Proposal #09: 1360-11-70, WISC 2021477
Fond du Lac Ave (STH 145)
Grantosa, Flagg/Florist Bridges
STH 145
Milwaukee County

1360-15-70, WISC 2021478
Fond du Lac Ave (STH 145)
Good Hope Rd I/C to 68th St
STH 145
Milwaukee County

This is Addendum No. 01, which provides for the following:

Added Plan Sheets – 1360-15-70	
Plan Sheet	Plan Sheet Title (brief description of why sheet was added)
330A-330F	SDD 14B32-08 Series; Concrete Barrier Single Slope (CBSS)

SDD 14B32-a Concrete Barrier Single Slope (CBSS)

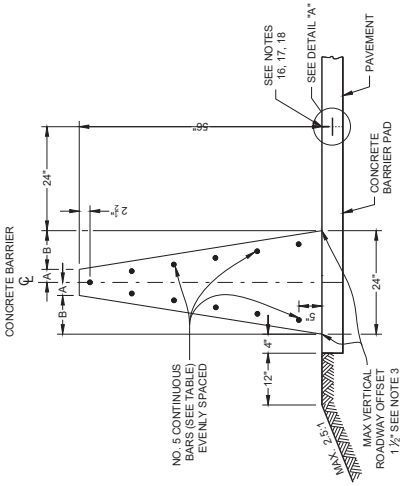
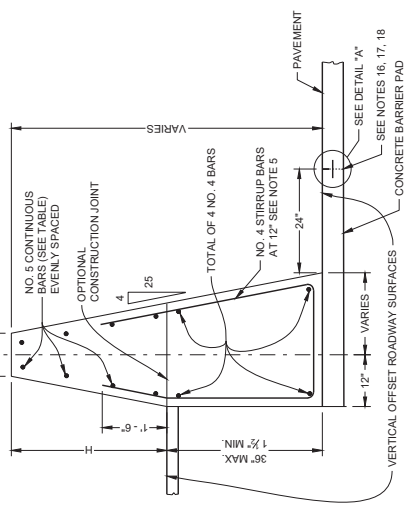
ADDENDUM to this SDD 8/4/2021: DELETE GENERAL NOTES 13 AND 14
